PACIFIC GAS AND ELECTRIC COMPANY

PGandE Letter No.: DCL-84-243

Re: Docket No. 50-275, OL-DPR-76
Docket No. 50-323 *oc* (2206)
Diablo Canyon Units 1 and 2
GAP Allegations

As stated in our letter DCL-84-239 of June 26, 1984, we are submitting responses to allegations from the Government Accountability Project (GAP) which have not been specifically addressed previously. These allegations are contained in GAP letters dated March 23, April 12, May 3, and May 31, 1984.

Figure 5-1

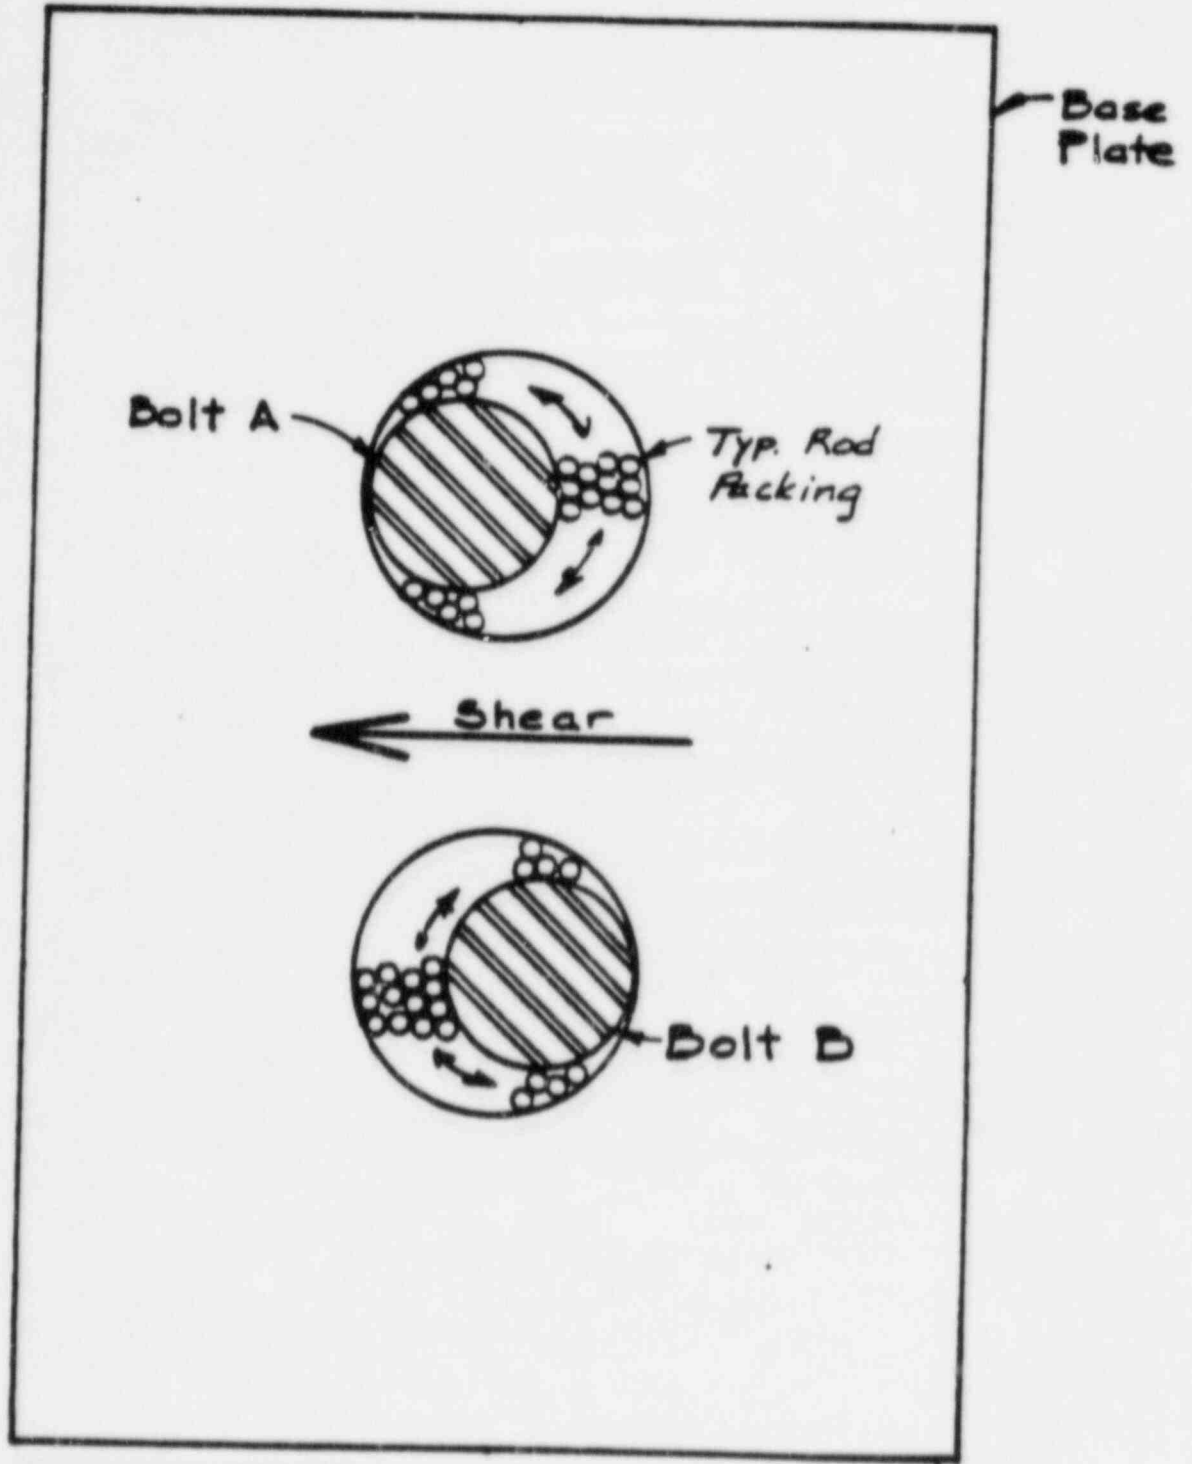
A concern has been raised regarding the acceptability of the shear transfer detail used for oversize baseplate anchor bolt holes. This detail, defined on drawing #447253 Rev. 4 (Zone A9), specifies the use of A36 steel rod (1/4-in. max. diameter) to fill the space between the baseplate and anchor bolt.

The worst effect of baseplate relative displacement occurs when one bolt is in initial contact with the baseplate and the other bolt is separated by loose rod packing (see Figure 5-1). In the illustrated case, Bolt B will resist the shear load immediately. Bolt A will gradually resist shear as the rod packing compacts. As Bolt B deforms, Bolt A will increasingly resist shear.

Bolt holes for rupture restraints baseplates inside containment were oversized for installation. The spaces between the baseplate and anchor bolt were packed with rod material to provide a positive shear transfer mechanism. Field inspection and engineering evaluation indicate that the baseplate may displace up to 3/16 in. to 1/4 in. relative to the anchor bolt. Shear deformations of this magnitude are considered acceptable based on overall structural system ductility and the nature of rupture restraint "one time" loading. Bearing force on the rod packing material was evaluated and considered acceptable. In summary, the rod packing shear transfer detail specified by drawing 447253, Rev. 4 is adequate for its intended function.
